National Science Conservation Centre
Twycross Zoo

Design & Access Statement Addendum

July 2024

NSCC and Residential Buildings

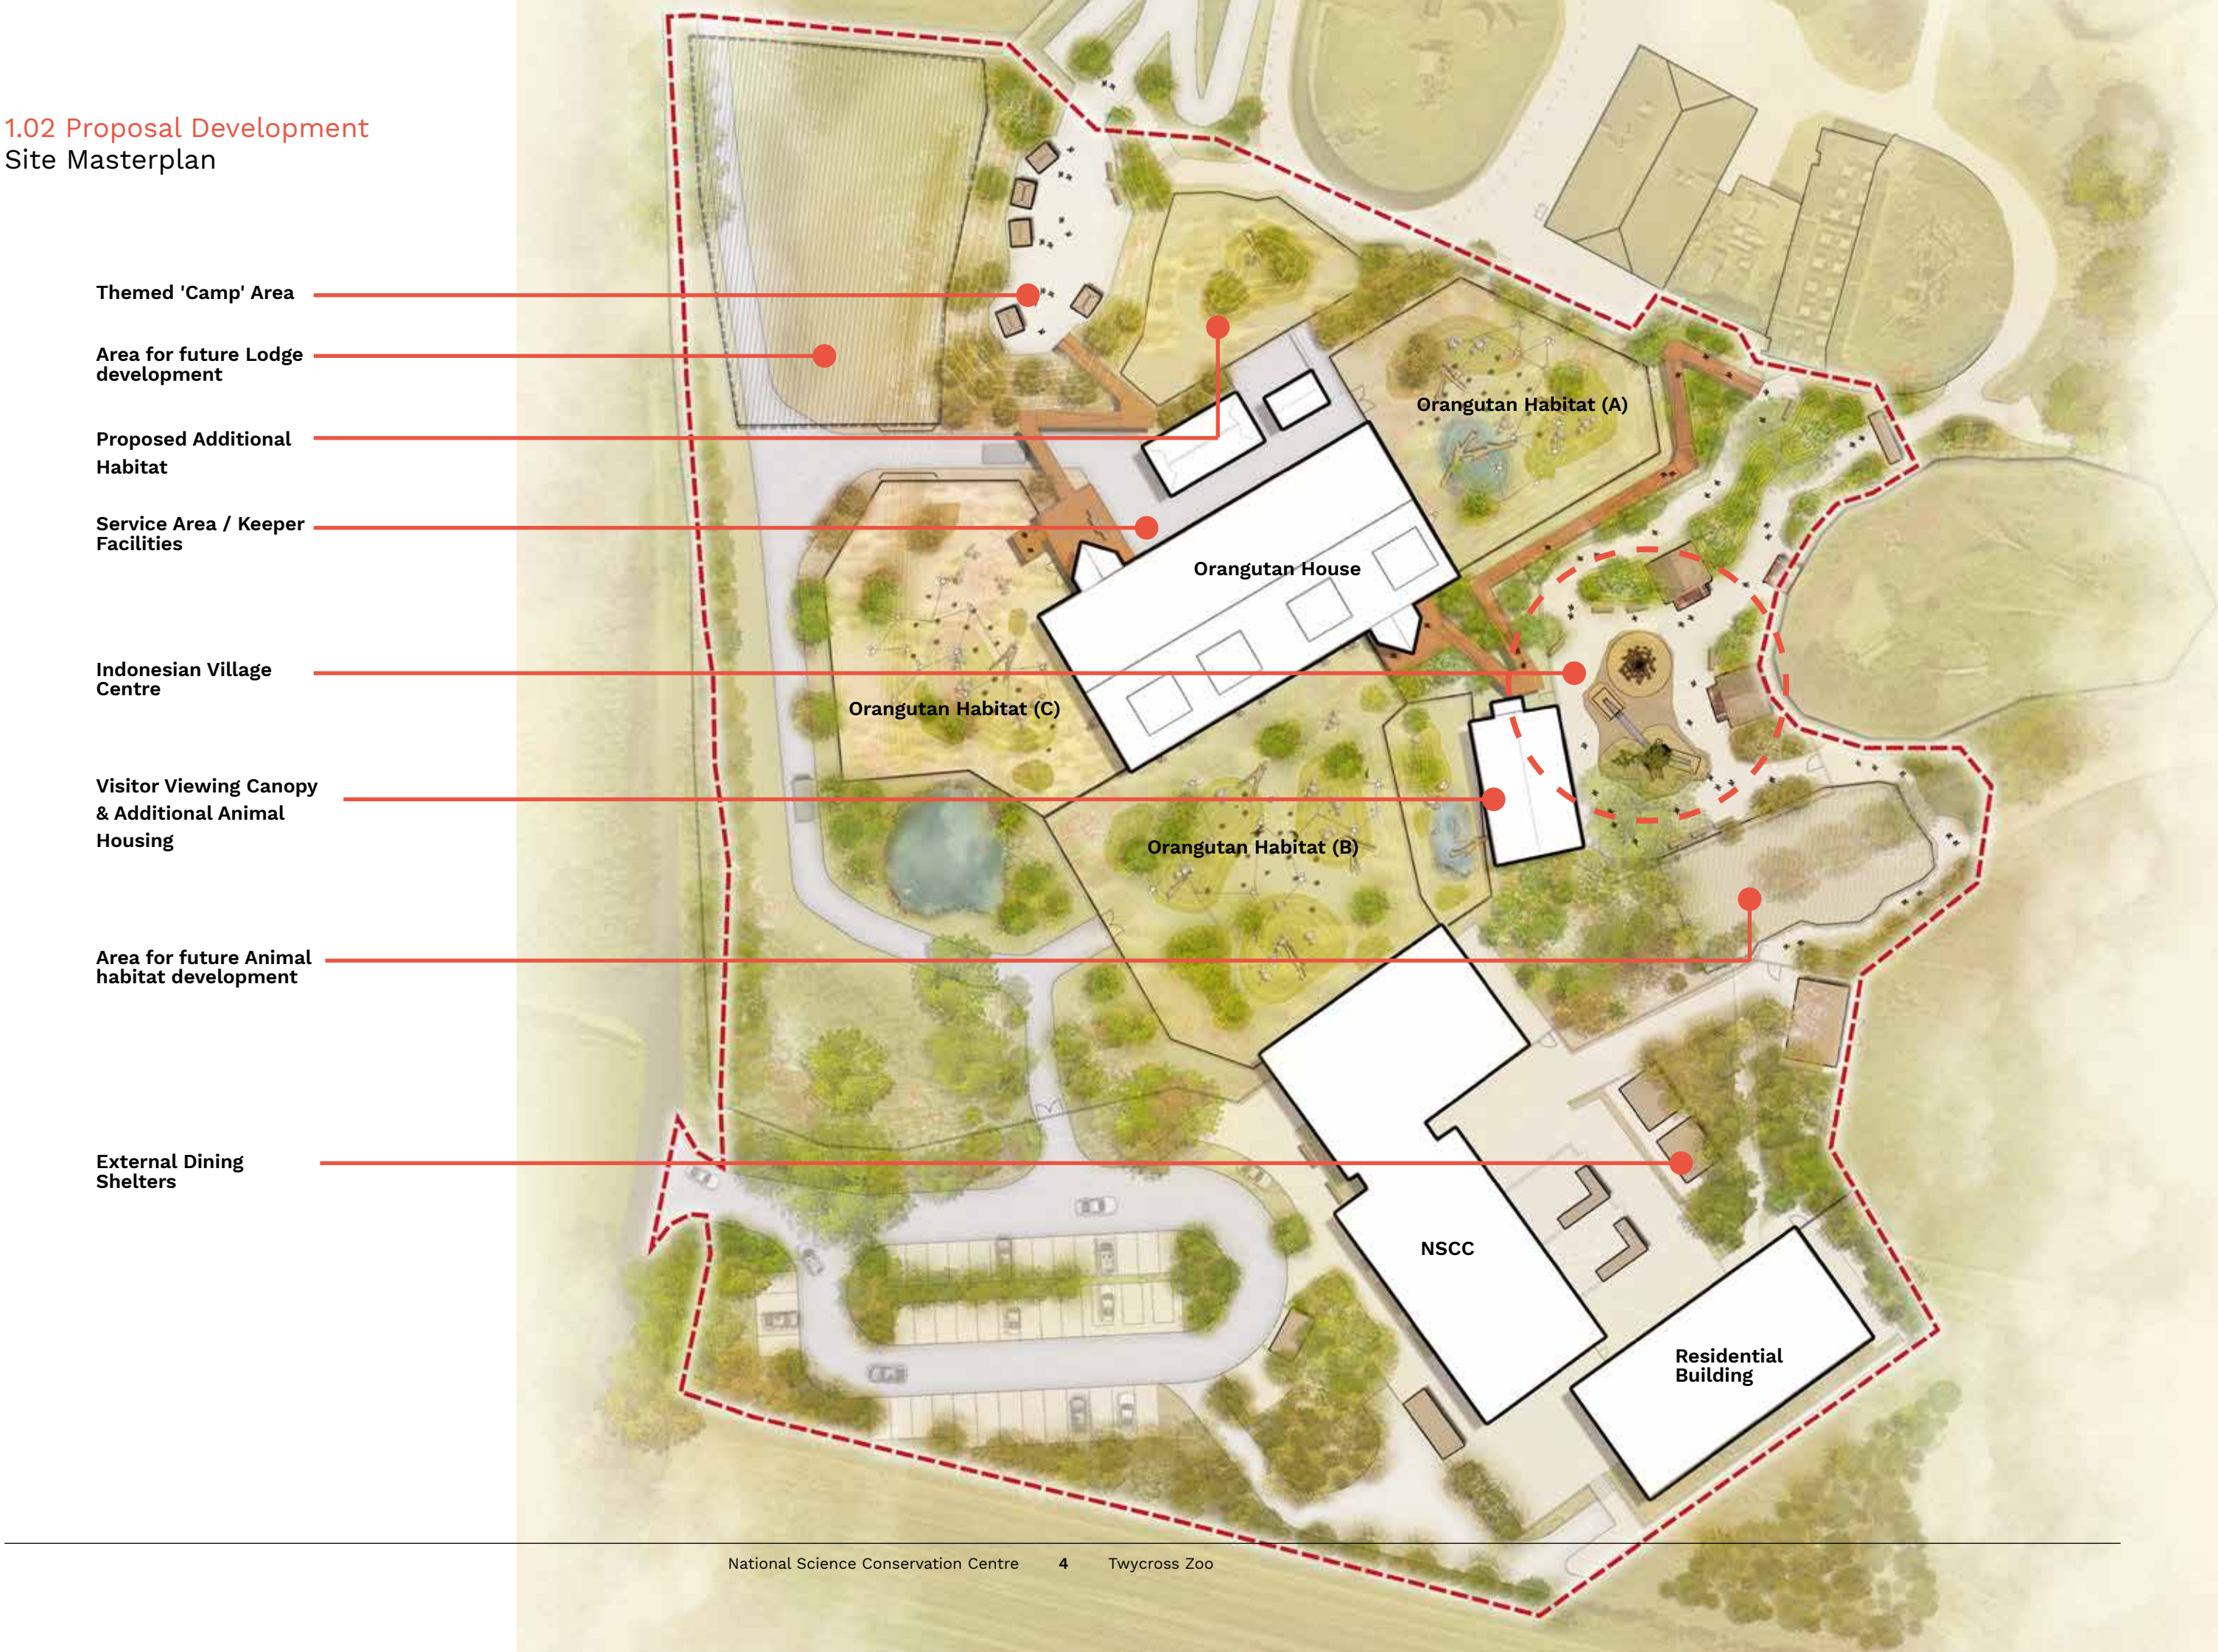
Refinement of the M&E and structural strategy has led to reducing the building height, which in turn has prompted a review of the elevational design to reconsider the new building proportions. A simplification of brick details and patterns to better suit the resulting fenestration arrangement and reduced height was required. The same brick type is proposed, but in two colours remaining consistent with the original design intent, previously attained through complex brick bonds and terracotta coloured concrete.

The main entrance to the NSCC building has been amended to following development of the technical design and improvements to the internal layout.

The lecture theatre block of the NSCC building is proposed to be all brick, corresponding to the simplification of the adjacent elevations.
